**CALIFORNIA COASTAL COMMISSION**

## STAFF REPORT: REGULAR CALENDAR

**Application No.:** 4-12-075

**Project Description:** Installation of six (6) free-standing ground-mounted solar unit/arrays and approximately 3,300 sq. ft. of roof-mounted solar photovoltaic panels on two existing structures within the Muse School Campus. Each free-standing ground-mounted solar unit/array will consist of a 28'5" ft. diameter solar array attached to a 19'1" ft. high monopole. The maximum height of the self-tracking solar units/arrays will vary between 19'1" ft. (closed/tilted position) to 33'6" ft. (open/vertical position) in height above existing grade.

**Exhibit 12  
 Proposed & Potential Solar  
 Unit/Array Relocation Sites  
 CDP No. 4-12-075**

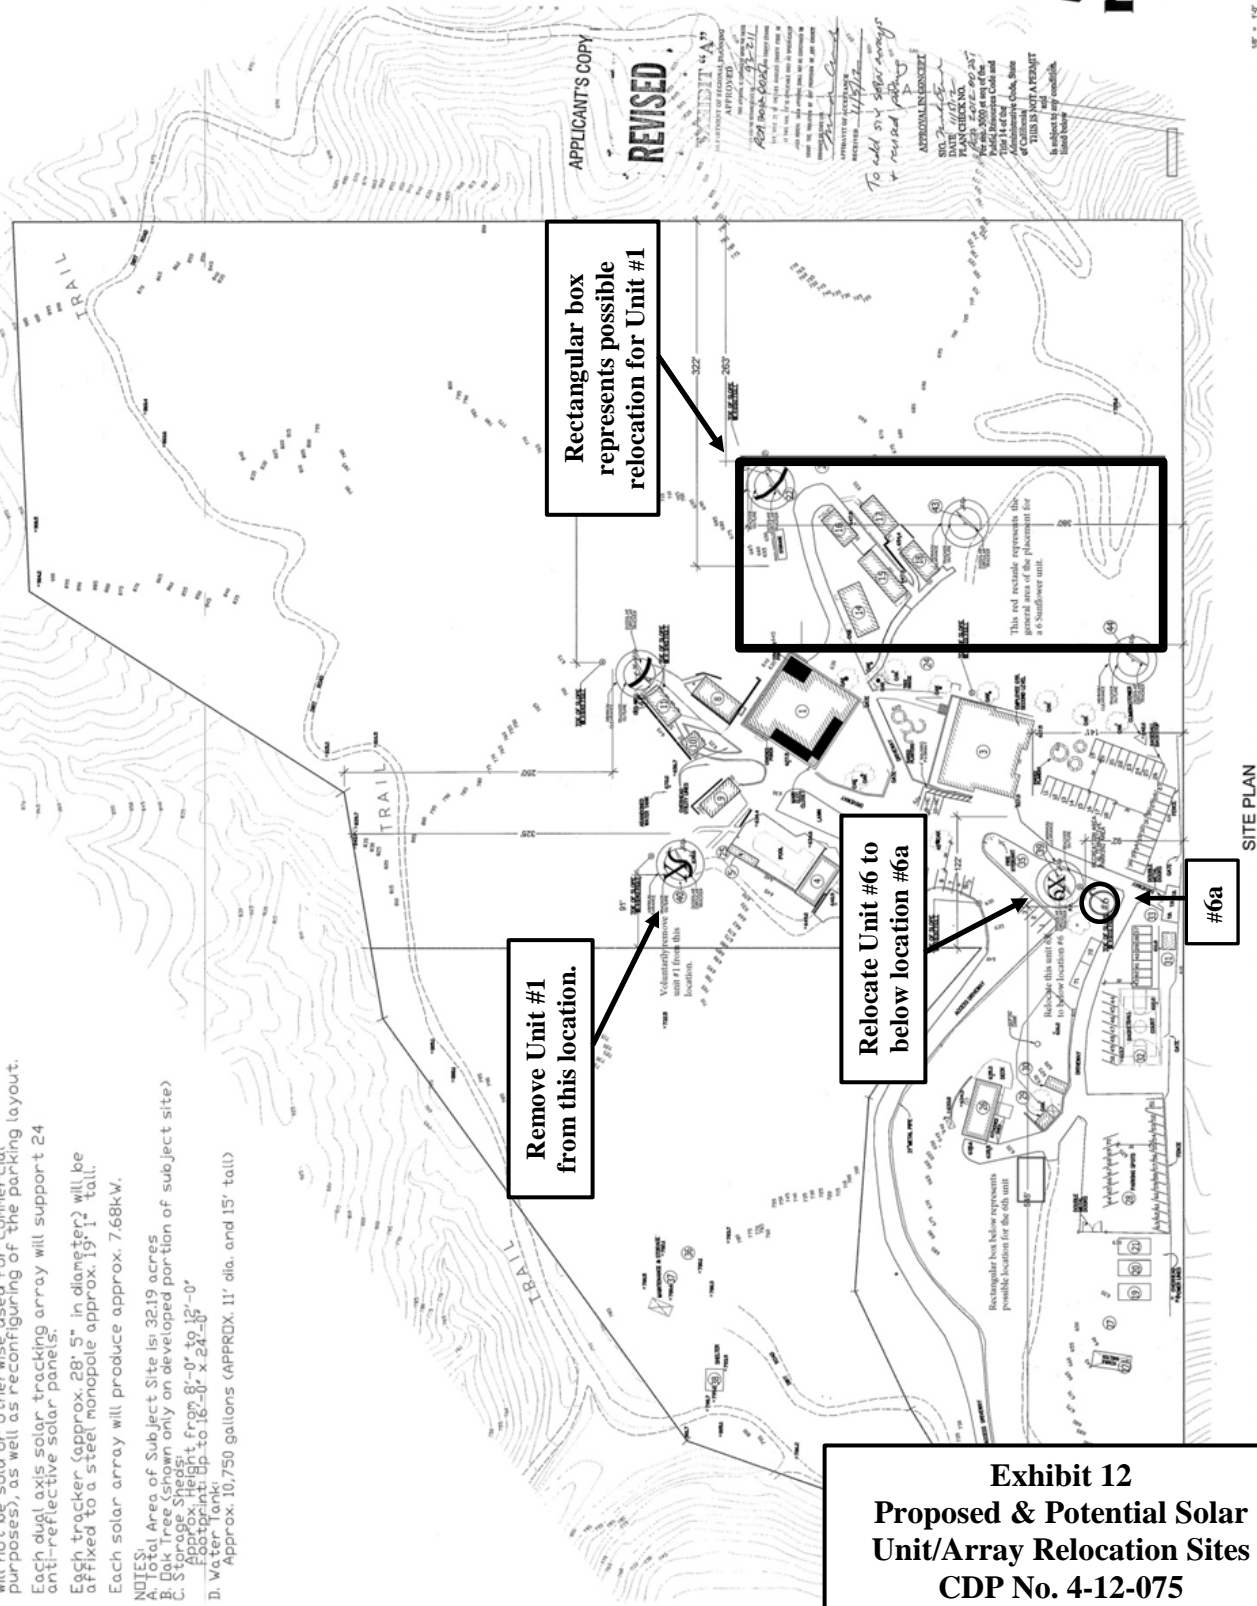
- (1) Solar Unit/Array No. 6 shall be relocated to the area of the site, as generally shown on Exhibit 12 of this staff report.
- (2) Revision to project plans to either 1) revise project plans to delete Solar Unit/Array No. 1; or 2) relocate Solar Unit/Array No. 1 to a new location within the vicinity of Solar Units/Arrays No. 3, 4, or 5 as generally shown on Exhibit 12 attached to this staff report and/or the installation of approximately 3,300 sq. ft. of roof-mounted solar photovoltaic panels on two existing structures within the Muse School Campus as shown on Exhibit 13. Proposed relocation of Solar Unit/Array No. 1 shall be in conformance with the following requirements:
  - (a) Sited within the required 200 ft. Los Angeles County Fire Department Forestry Division fuel modification zones for existing habitable structures on site.

However, in coordination with Commission staff, the applicant has revised the originally proposed project to address these impacts. Specifically, the applicant has revised the project to relocate Solar Unit No. 6 approximately 25-30 feet further to the west, in order to make use of existing landscaping and vegetation on site to screen the unit from public views. Moreover, the applicant has revised the project to either delete Solar Unit No. 1 or relocate the unit to a location on the project site adjacent to Solar Units 3, 4, or 5 where it would not be visible from Piuma Road. In addition, in order to ensure that the potential elimination of Unit 1 would not result in a reduction of the power generating capacity of the system, the applicant has also revised the project to include the installation approximately 3,300 sq. ft. of roof-mounted solar photovoltaic panels on the two existing structures on site, shown on Exhibit 13. However, the applicant has not yet submitted revised project plans to represent the proposed changes noted above and; therefore, the Commission finds it necessary to impose **Special Condition One (1)**, which requires the applicant to submit revised plans, for the review and approval of the Executive Director, that requires the relocation of Solar Unit/Array No. 6 and either the deletion of Solar Unit No. 1 or relocation of this unit within the area generally shown on Exhibit 12. In addition, the revised plans may include the installation of 3,300 sq. ft. roof-mounted solar photovoltaic panels, if necessary. Special Condition One (1) further requires that Solar Unit/Array 1 may only be relocated to a location that will not be visible from Piuma Road, will not require vegetation removal or grading, and will be sited within the existing 200 foot fuel modification areas of existing habitable structures on site. Only as so conditioned will the development minimize the visibility of the development from public viewing areas and thereby minimize adverse impacts to visual resources to the maximum extent possible.
